**AMENDMENTS TO THE DRAWINGS**

## **REMARKS**

Title: HIGH VOLTAGE CABLE ASSEMBLY WITH ARC PROTECTION

Docket No.: 14374.111 Serial No.: 10/826,774

Fig. 2B

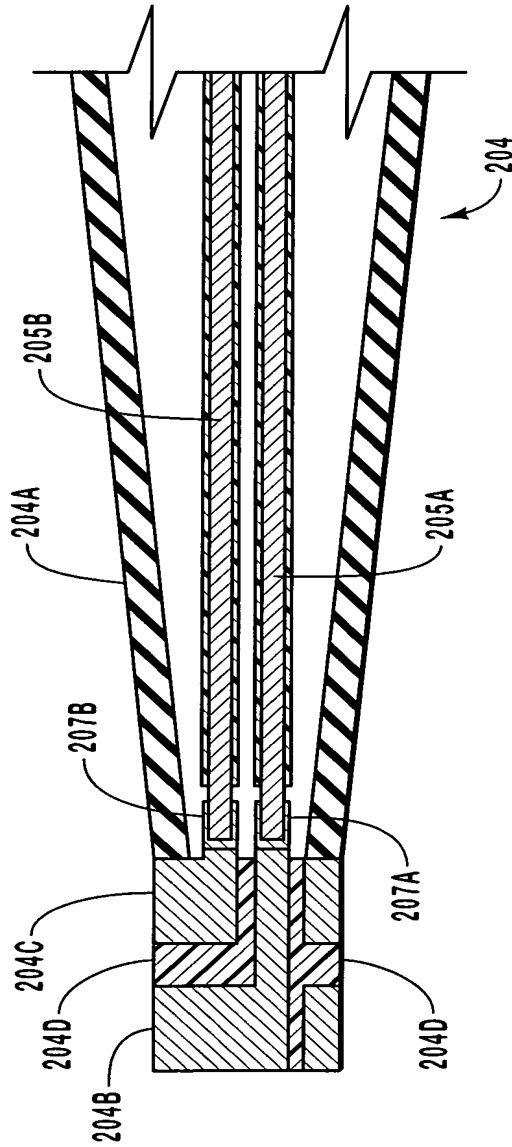
#### **1. plurality of conductors of a cable**

3. ***plurality of electrical contacts in electrical communication with conductors of the cable***

9. ***plurality of conductive elements within the terminal***

10. ***conductive elements in electrical communication with the conductors of the cable***

11. ***plurality of contacts in electrical communication with the conductive elements***

The attached sheet 3 of drawings includes new Figure 2B. Previous sheet 3, containing Figures 3 and 3A, has been renumbered as sheet 4. No new matter is believed to be introduced as a result of the aforementioned amendments to the drawings.

In light of the addition of Figure 2B herein, showing conductors 205A and 205B, Applicant submits that the objection as to this feature should be withdrawn.

Applicant submits that in light of the addition of Figure 2B herein, illustrating electrical contacts 204B and 204C in electrical communication with conductors 205A and 205B of a cable, the objection as to this feature should be withdrawn.

Applicant submits that in light of the addition of Figure 2B herein, illustrating a plurality of conductive elements 207A and 207B disposed within the terminal 204, the objection as to this feature should be withdrawn.

Applicant submits that in light of the addition of Figure 2B herein, illustrating conductive elements 207A and 207B in electrical communication with the conductors 205A and 205B of the cable, the objection as to this feature should be withdrawn.

Applicant submits that in light of the addition of Figure 2B herein, illustrating a plurality of contacts 204B and 204C in electrical communication with the conductive elements 207A and 207B, the objection as to this feature should be withdrawn.
